Date: November 29<sup>th</sup>, 2021

To: Dan Osoba, Planner II  
City of Aurora Planning Department

This document is a response to the Harmony – Site Plan / Phase 5  
(Application Number: #1574871) Pre-Application Meeting comments we received on September 30,  
2021 from the Office of Development Assistance. Responses are below in **RED**:

## 2. Land Use 2A. *Master Plan Amendment*

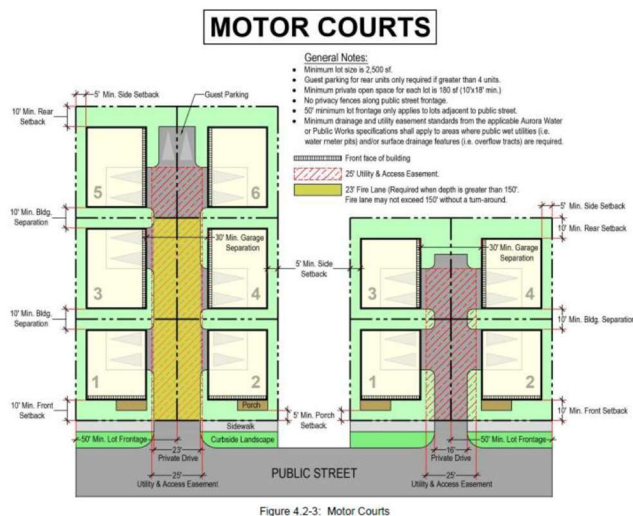
Based on the proposed concept plan, the Harmony Master Plan will require amendments to several tabs. In the first submission, please demonstrate the density modifications for all impacted Planning Areas within this development area and where the density is changing to accommodate the increases for the carriage homes, if applicable. The originally approved unit count may not be increased for the overall Master Plan. Please provide a tracking table that clearly identifies the running total unit count and small lot allocation to keep track of the density changes and the overall unit count. As discussed in the Pre-Application Meeting, if any infrastructure planning areas or phasing of that infrastructure is to change with this development, please identify that change within the Letter of Introduction and modify the Public Improvement Plan (PIP). This would include any modifications to the drainage channel, park and open space location, and trails. These modifications should also include new triggers for infrastructure and interim sections for incomplete roadways. Please see Public Works comments within this letter for further details.

- Please refer to the Master Plan Amendment narrative for density modifications and changes to the planning areas.
- The original unit count has not been increased.
- A tracking table has been provided on the cover of the Site Plan for overall unit count within Harmony
